D-3338 Somersby

Acknowledgement Of Plans Submittal ONLY!

Second Floor

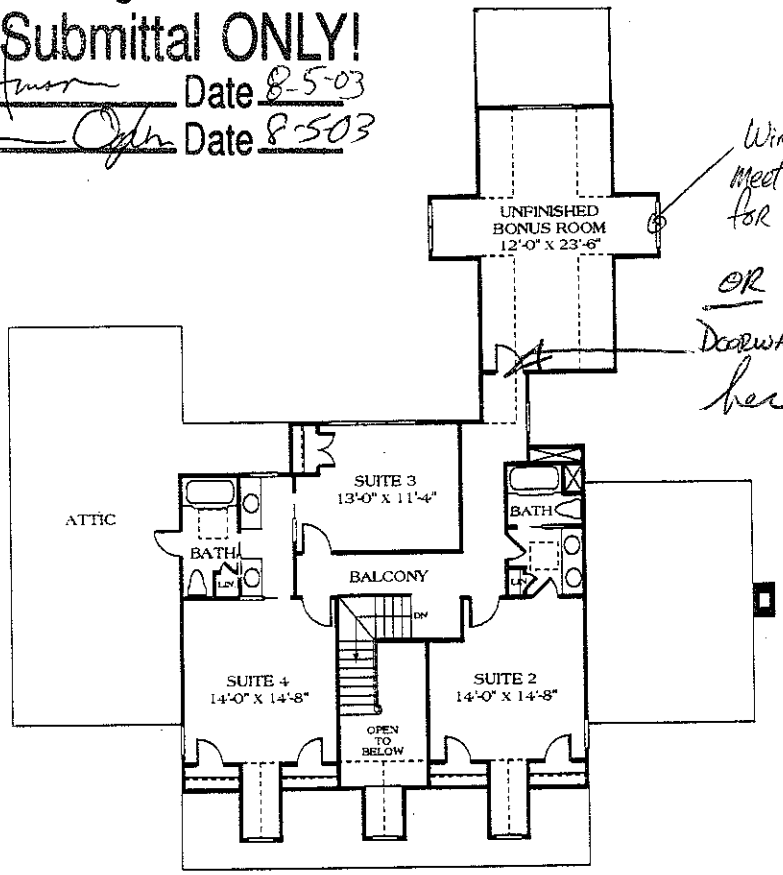
Windows will not meet egress Requirements for Bedrooms.
